TO: Kori Benton, Historic Preservation Officer
FROM: John R. Andrews, P.E., City Engineer
DATE: April 24, 2015
PROJECT: A1 Kitchen Remodeling Driveway Variance
3306 South 7th Street
TRC No. 15-12000004

A1 Kitchen Remodeling
US Highway 1
Petition for Variance
St Lucie County Public Works/Engineering Comments
April 20, 2015

**Re: Technical Review Comments- Planning Department
A1 Kitchen Remodeling
3306 S 7th Street**

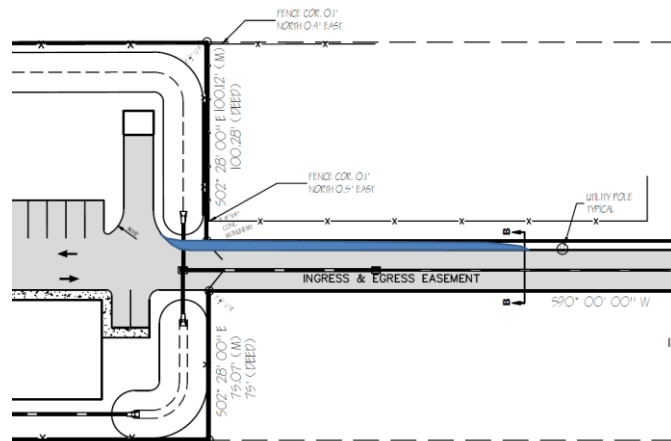
3. The proposed driveway plan should feature paved connections to abutting properties. Furthermore, based upon the anticipated delivery trucks accessing the site, it is recommended to expand the width of the access aisle towards US Highway 1 to assist with clearing turning vehicles from US 1. Both notes are presented below:
